Model : Saddle Finisher -D2**Ref. No.** : FF-T01-W-000112-01**Date** : July 3, 2000© Canon (UK) Limited

Location : SADDLE ASSEMBLY**Subject** : PREVENTING BLACK STRIPES IN IMAGES (CAUSED BY TONER SMEAR)**Reason** : Black stripes can occur in images of a double-sided copy made in 'fold mode'. The symptom may be corrected as instructed herein.**Details** : <Symptom>
Black stripes occur on double-sided copies because of a toner smear.

Fig. 1. Saddle Holding Roller Assembly

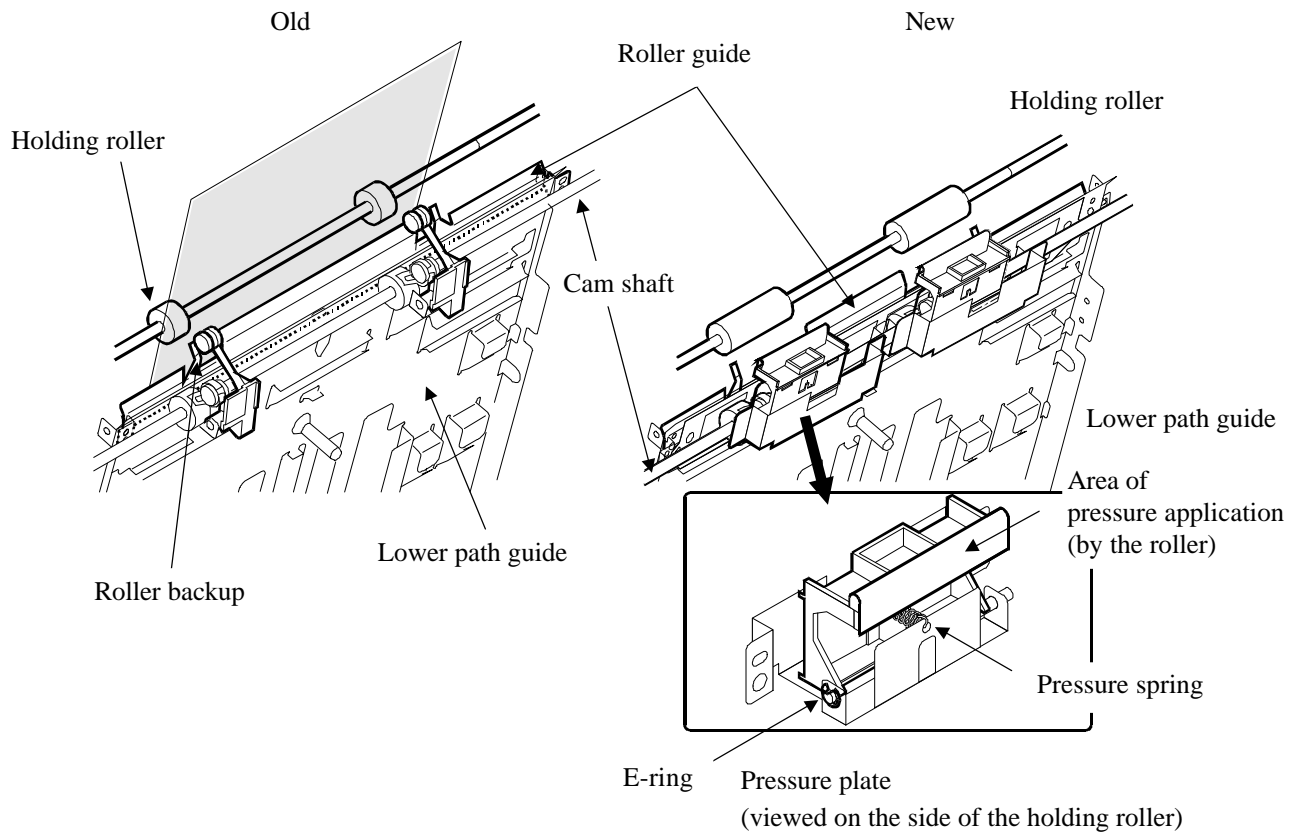
When paper is being moved in 'fold mode', the holding roller (FB3-7920) and the roller backup (FB3-7927) cause a smear on the paper, resulting in black stripes in copy images at intervals of about 185 mm, corresponding to the location of the roller.

The following changes will be made to distribute the pressure imposed by the roller backup while paper remains in contact with the holding roller, thereby reducing the occurrence of black stripes caused by toner smears:

1. Instead of the roller backup, a pressure plate (equipped with cushion sponge) will be used.
2. To accommodate change 1 above, the width of the holding roller will be increased to 60 mm from about 10 mm, (thereby ensuring the present feeding power).

3. To accommodate change 1 above, the cam of the cam shaft will be relocated so that the pressure will be applied to the center for the pressure plate.

4. To accommodate change 1 above, the screw hole used to mount the pressure plate of the lower path guide will be relocated. (The replacement may prove to be difficult and, therefore, the lower path guide is not made available as a service part.)

5. To accommodate change 2, the cut-off of the roller guide will be enlarged.
6. To reduce the time during which the holding roller remains in contact with paper and, thereby to reduce the distance over which the paper rubs against the roller, the software will be revised (ROM Ver. 3*).

Fig. 2. Holding Roller Assembly for Field Measures

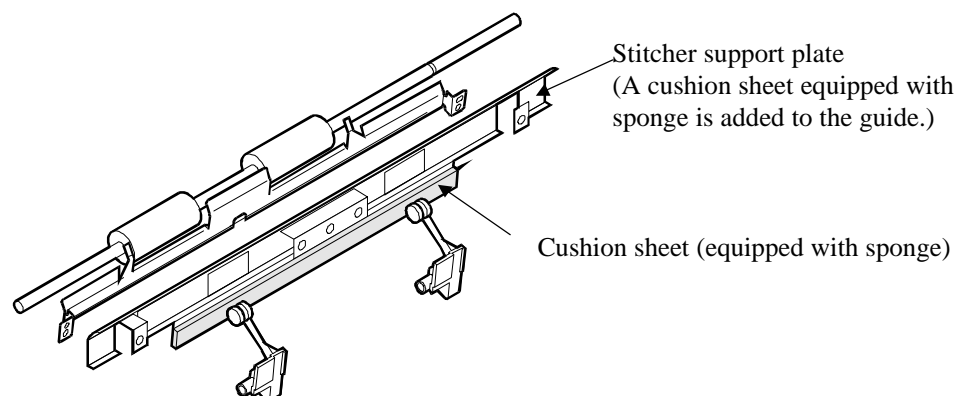
Add the cushion sheet (equipped with sponge) to the guide of the stitcher support base to distribute the pressure of the roller backup, thereby reducing black stripes caused by a toner smear; the addition of the cushion sheet will call for the following changes:

1. Increase the holding roller width from about 10 mm to 60 mm (to retain feeding power).
2. To accommodate change 1 above, enlarge the cut-off in the roller guide.
3. To accommodate change 1 above, change the pressure of the roller backup.
4. To accommodate change 1 above, change the force of the tension spring of SL33 (holding roller locking control solenoid).
